TECHNICAL CLARIFICATIONS ON TENDER KZN027 -THE PROVISION FOR THE DESIGN, MANUFACTURE, TESTING, SUPPLY, DELIVERY, OFF-LOADING, INSTALLATION AND COMMISSIONING, (INCLUDING SPARES AND TRAINING) OF MV INDOOR PRIMARY METAL- ENCLOSED SWITCHGEAR.	CENTRAL EAST CLUSTER
---	---	---------------------------------

1. TECHNICAL CLARIFICATIONS, CLARIFICATION MEETING QUESTIONS AND RESPONSES

Figure 1. Single line diagram for proposed withdrawable

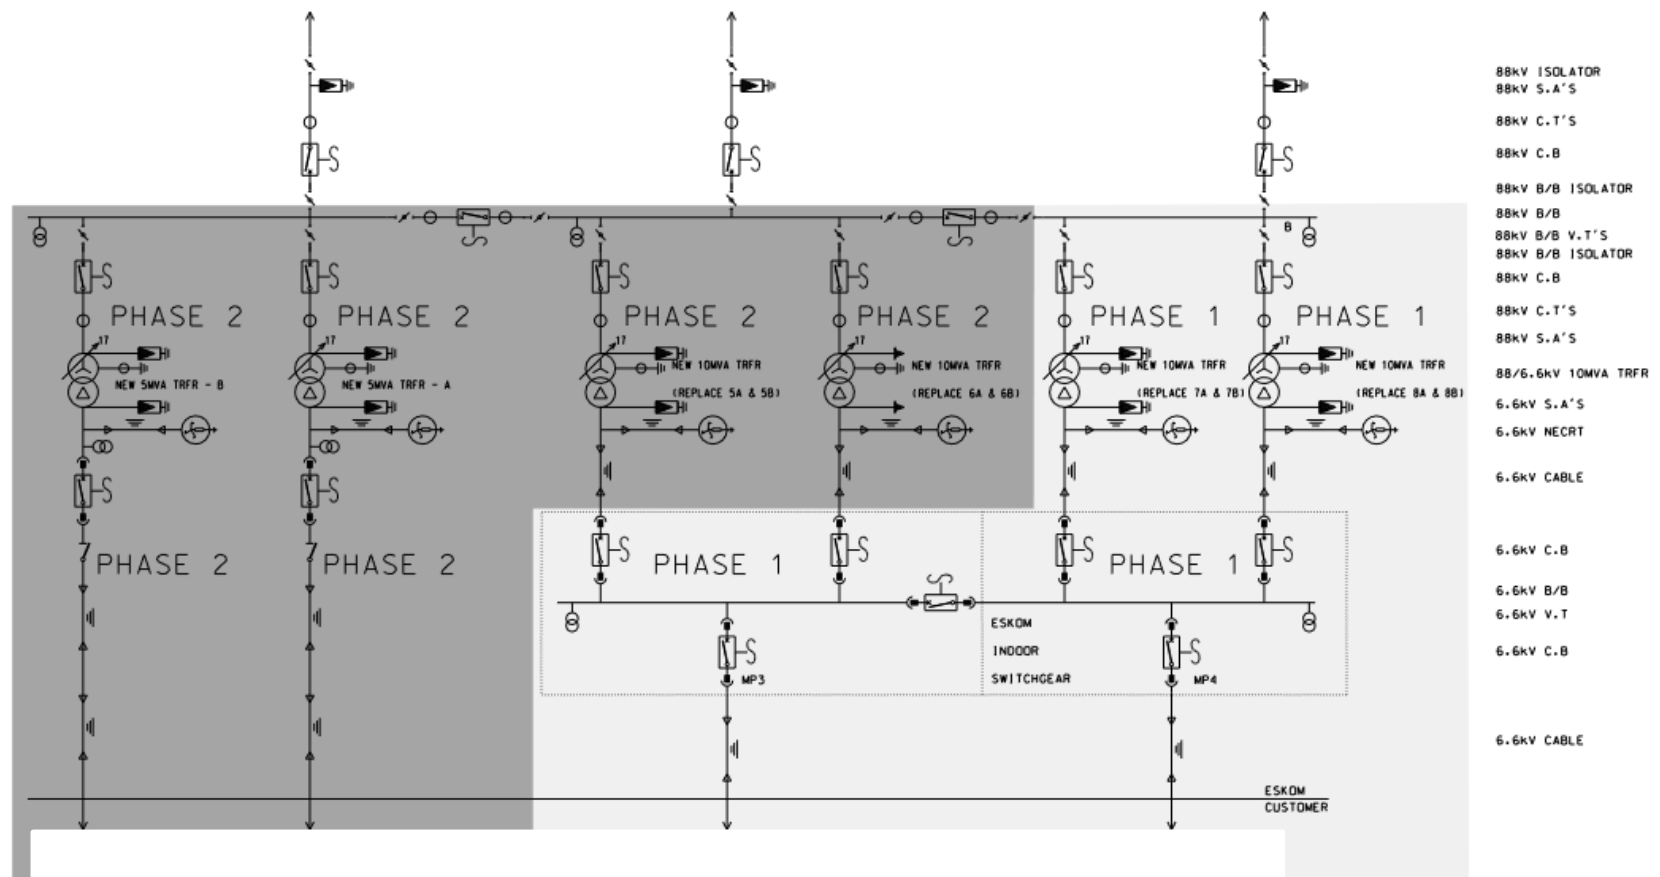
For SAP no items below in a) and b) it was queried as to whether there is associated feeder panels listed as required to work together with these items?

- a) 0170209 BKR PANEL 11kV 2500A 25kA B/S D6258
- b) 0170210 BKR PANEL 11kV 2500A 25kA INCMR D6258

For the project required refer the below points a)-e) and the single line diagram in figure 1:

- a) The board will have 4 x transformer incomer panels. Each panel will be supplied by an 88/6.6kV 10MVA transformer;
- b) The board busbar conductors and bus-section panels are to be 2500A rated;
- c) The board will have 2 x panels that will supply the customer. Each panel needs to handle the peak load of 20MVA @ 6.6kV;
- d) The board shall have a 6.6kV VT panel at each end; and
- e) The Eskom SAP no's are below:
 - i) Transformer incomer panel: 0239690 (11kV 1250A 25kA FDR(B))
 - ii) Bus-section panel: 0170209 (11 kV 2500 A 25 kA B/S)
 - iii) Customer panel: 0170210 (11 kV 2500 A 25 kA)
 - iv) VT Panel: 0239687 (6.6 kV/110 V 50 VA 0.2(B))
